Product Safety Notification

Bulgin 900 Series Sockets

<b>Model No.</b>	<b>Stock no.</b>
PX0911/03/S	RS 344-4043
PX0911/04/S	RS 344-4059
PX0941/04/S	RS 345-0824

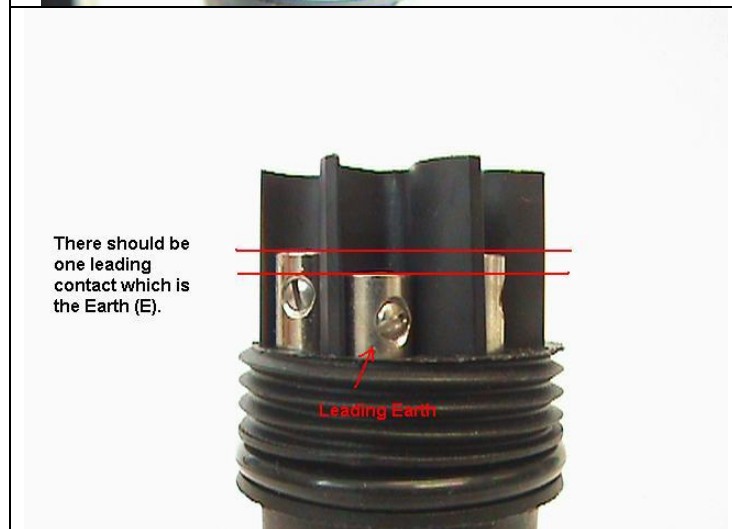
The earth terminal on these connectors is designed to make connection first and break connection last.

To achieve this, the earth socket terminal should have been mounted forward of the remaining terminals.

There is a possibility that this is not the case and an adjacent terminal may instead be mounted forward.

Please refer to the enclosed sheet for further details of the fault and directions as to how to determine if the connector(s) you have are affected.

If you find that you have one or more of the affected sockets and require replacement please contact our Customer Care Team on tel 01536 444 386.
